WANGAN MIDNIGHT TECHNICAL BULLETIN

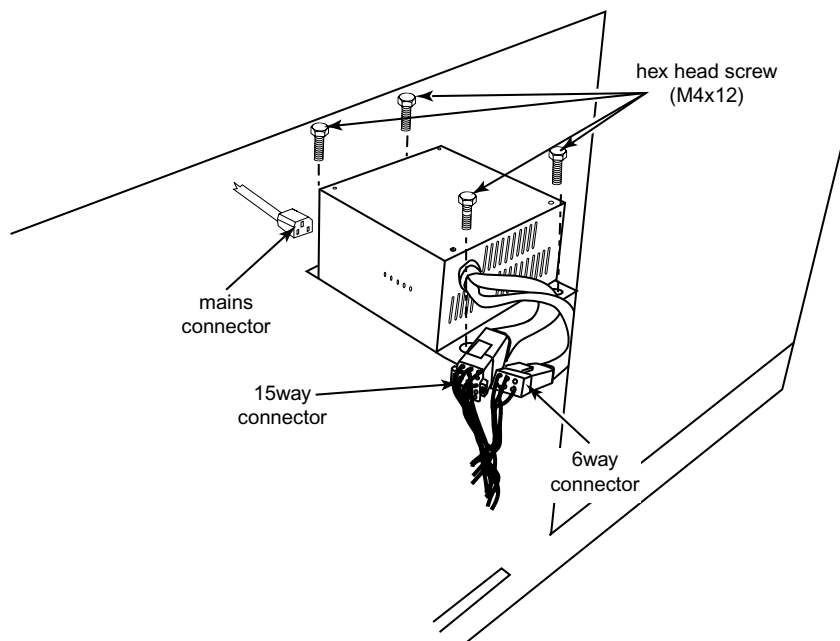
1. Switch the game off and disconnect from the power supply.
2. Remove the lower rear door from the Monitor Cabinet.
3. Disconnect six (6) connectors from the right hand Game PCB Assy. (as viewed from the rear of the cabinet.)

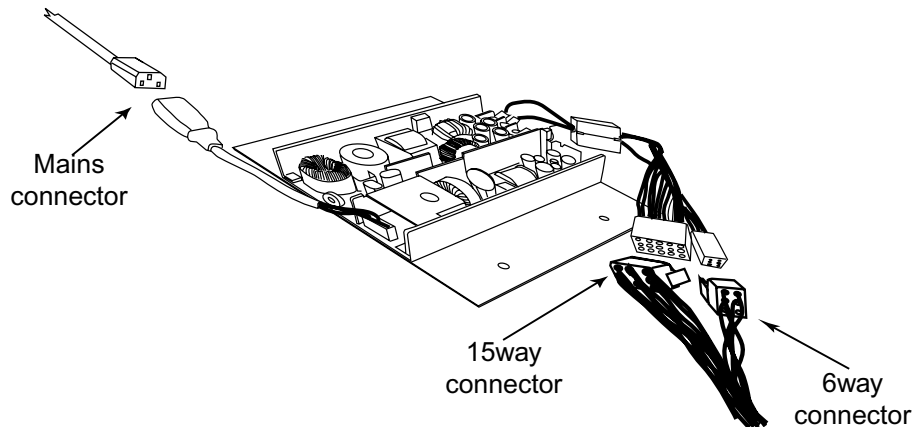
4. Slacken 4 off hex head nuts (M5) and remove the Game PCB Assy.
5. Disconnect the 15way and 6way connectors and the mains connector from the existing Power Supply.

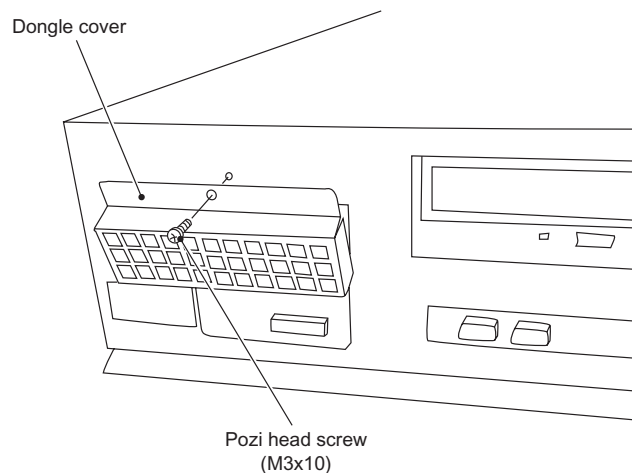
6. Remove 4 off hex head screws (M4x12) and remove the existing Power Supply.
7. Fit the new Power Supply using the 4 off hex head screws removed from the old Power Supply.
8. Connect the 15way and 6way connectors and the mains connector on the new Power Supply.
